July 28, 2024

Re: 319 Park Avenue, Sanford NC - Structural observation and assessment re: existing foundation and proposed remediation

**Site Photo 2:** "New" joist support girder line at joist bearing end closes to Park Ave.

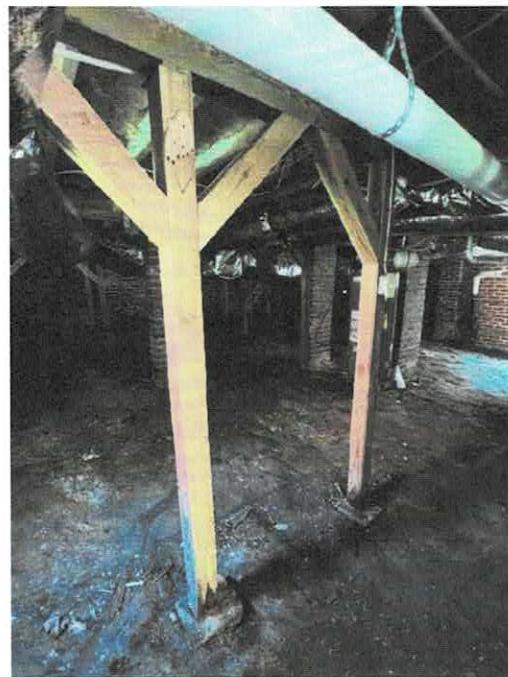
To remedy this issue, a new support line, consisting of a double 2x10 girder w/ 4x4 support posts had been installed approximately 12" off of the wall, to provide a new line of primary support to the joists in question, and reduce/ remove the bearing load along the foundation wall. The new posts were supported by masonry pavers to spread the load to the compacted soil below, similar to the other/ existing intermediate supports constructed under the house.

Upon my observations, this construction/ configuration is structurally sound, and provides adequate permanent support for the primary floor of the home, and is in adherence with the requirements of the current North Carolina Residential Building Code, for foundations and foundation support. With that said, while the existing wood support posts are sound in their current condition, discoloration was noted at their base which signifies direct exposure to moisture/ moisture transfer through the foundation below. The wood was probed and did not
